TO: All Bidders May 19, 2020
FROM: Janice Kisch, Purchasing Specialist
SUBJECT: Bid 537 Ventura College Learning Resource Center Chiller Replacement

Bid 537 Ventura College LRC Chiller Replacement – ADDENDUM 1

- A. Replace M1.0 with M1.0 Addendum 1 dated 5-14-20
Added Factory Supplied Circuit Breaker
- B. Replace M2.0 with M2.0 Addendum 1 dated 5-14-20
Revised piping and electrical notes
- C. Replace M2.1 with M2.1 Addendum 1 dated 5-14-20
Added detail 5
- Replace M3.0 with M3.0 Addendum 1 dated 5-14-20
Revised butterfly valve style

CHILLER SCHEDULE

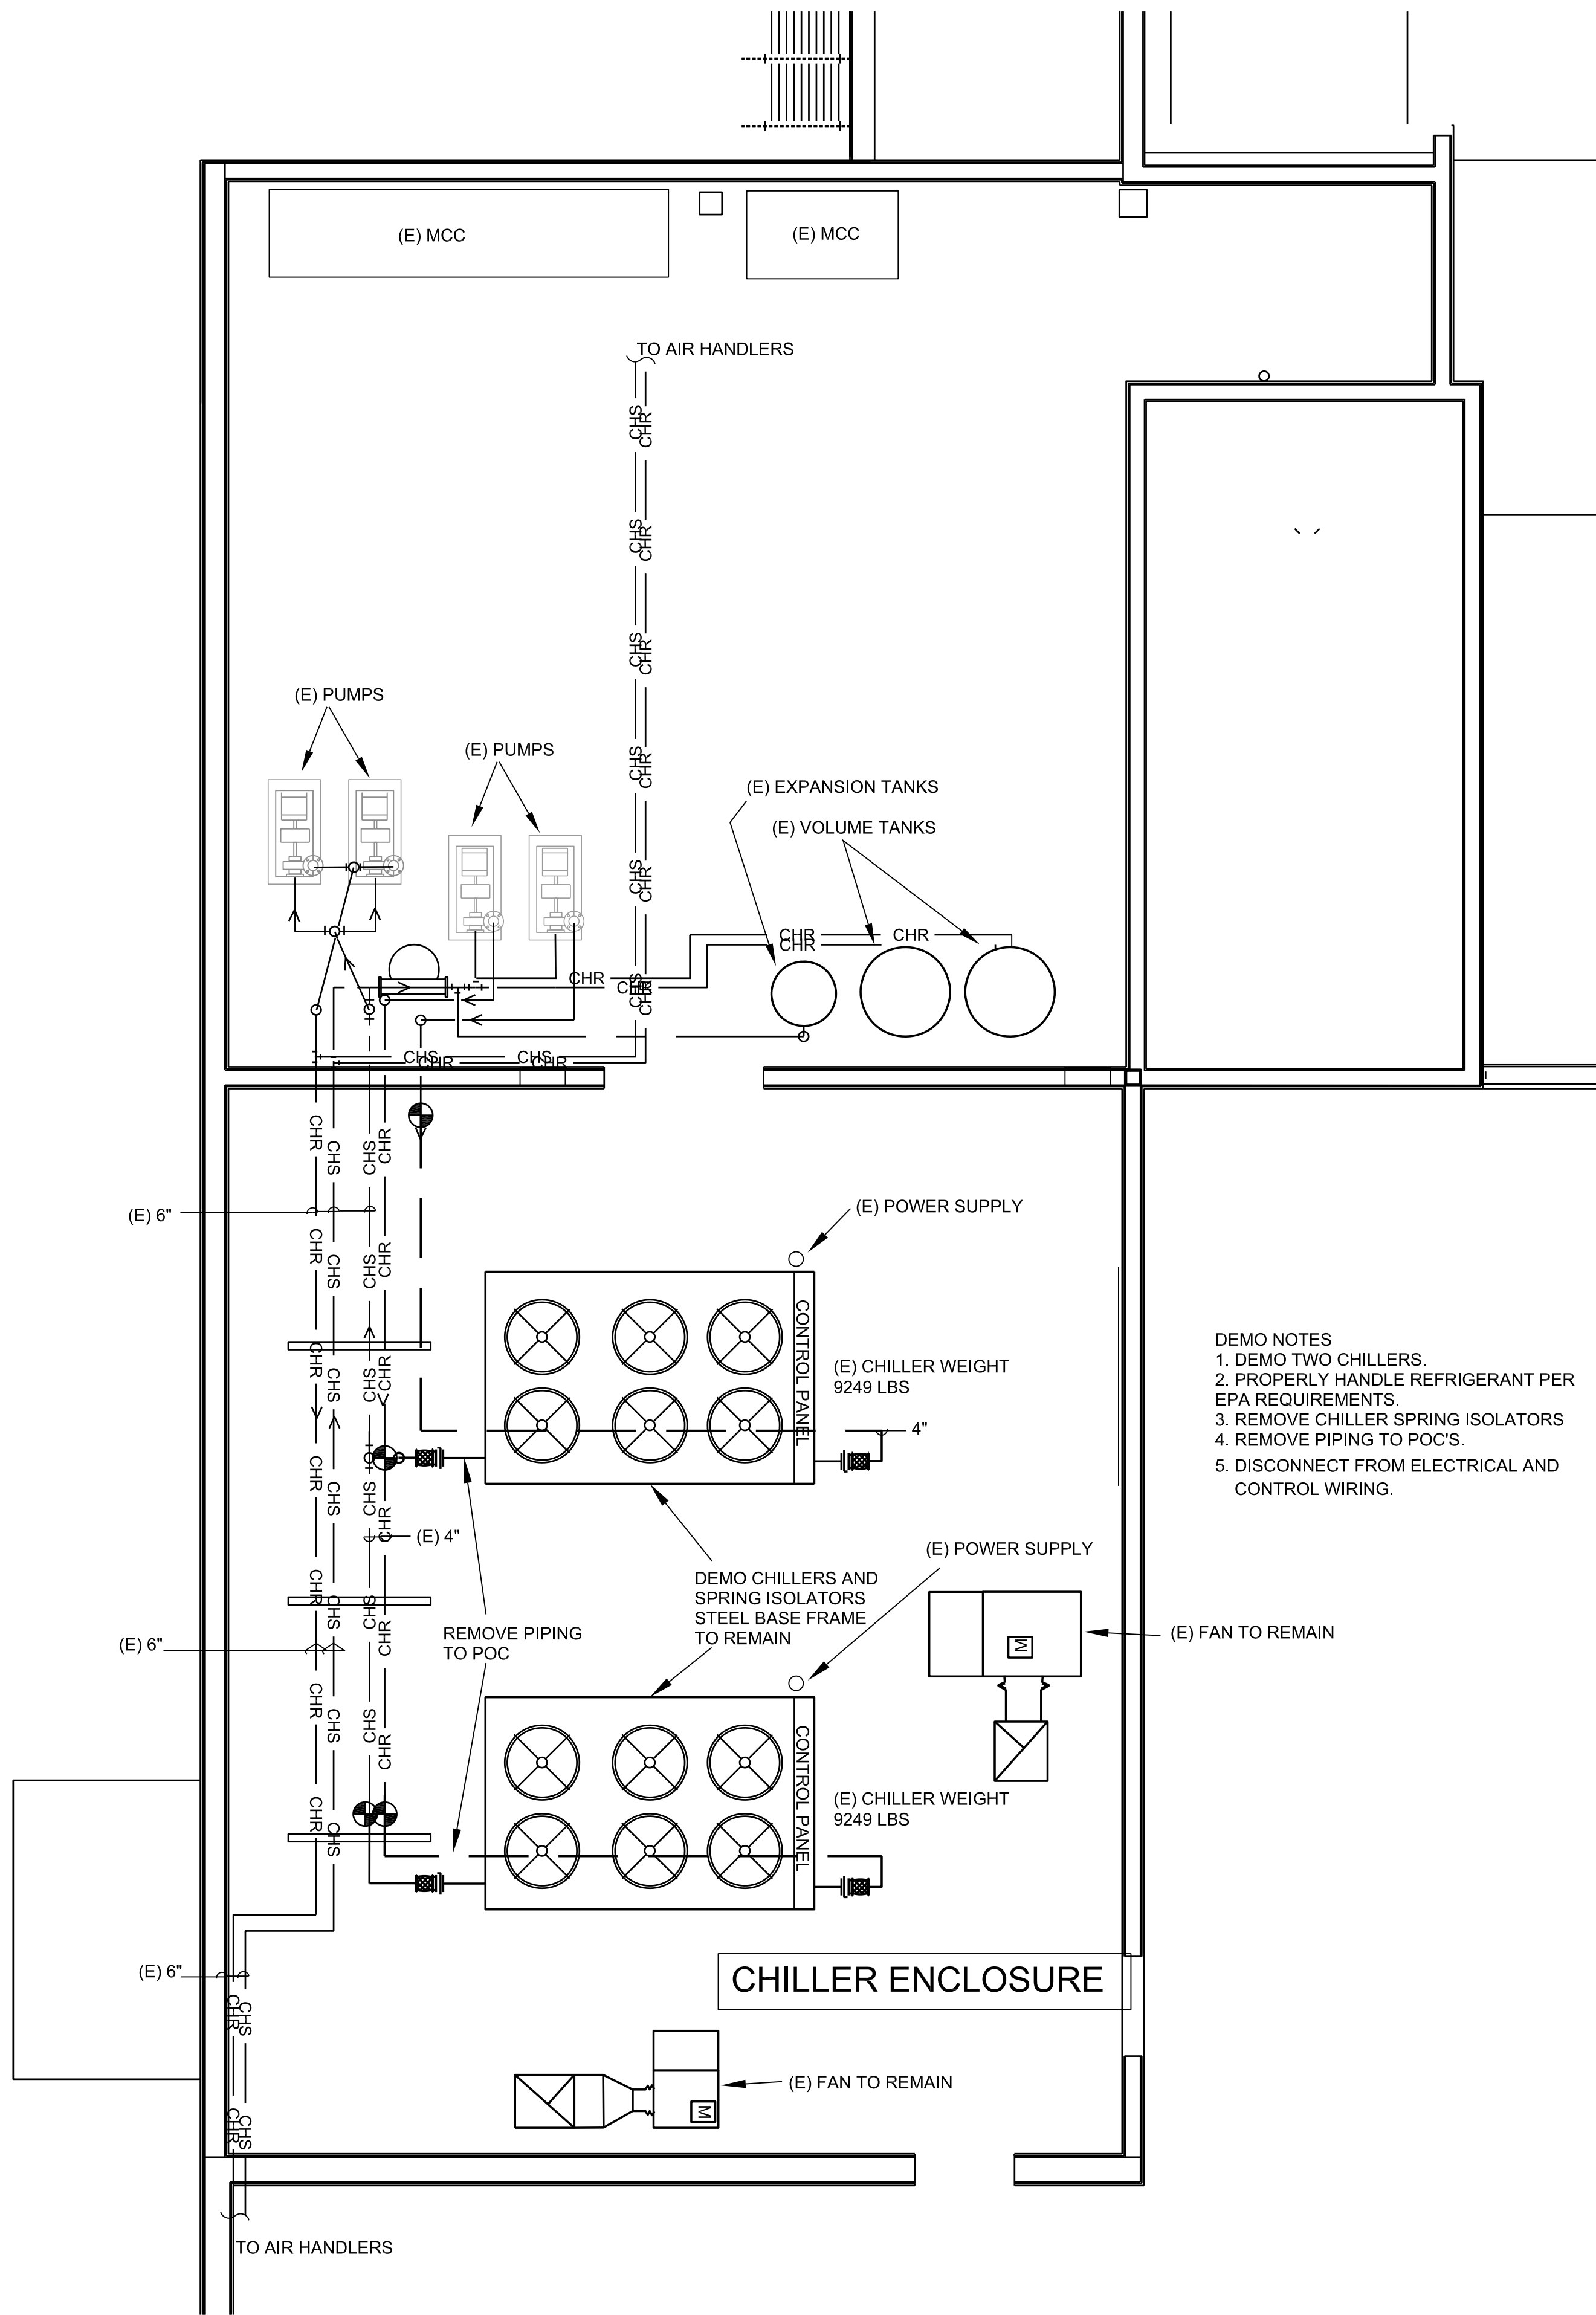
Question #4 Electrical disconnect for each chiller (480 volt 300 amp) is more than 20 lbs. That being said, would you still like us to mount the disconnect on the chiller?

Answer - Delete disconnect. Add high fault circuit breaker option on Trane chiller. See M1.0 Addendum 1 (delta2)

Answer. Demo any disconnects on existing chiller. New chillers shall have factory installed circuit breakers. Add permanent tag "LOCKOUT CHILLER AT MCC PRIOR TO WORKING ON ANY POWER ELEMENTS" Some strut may be required for conduit installation.
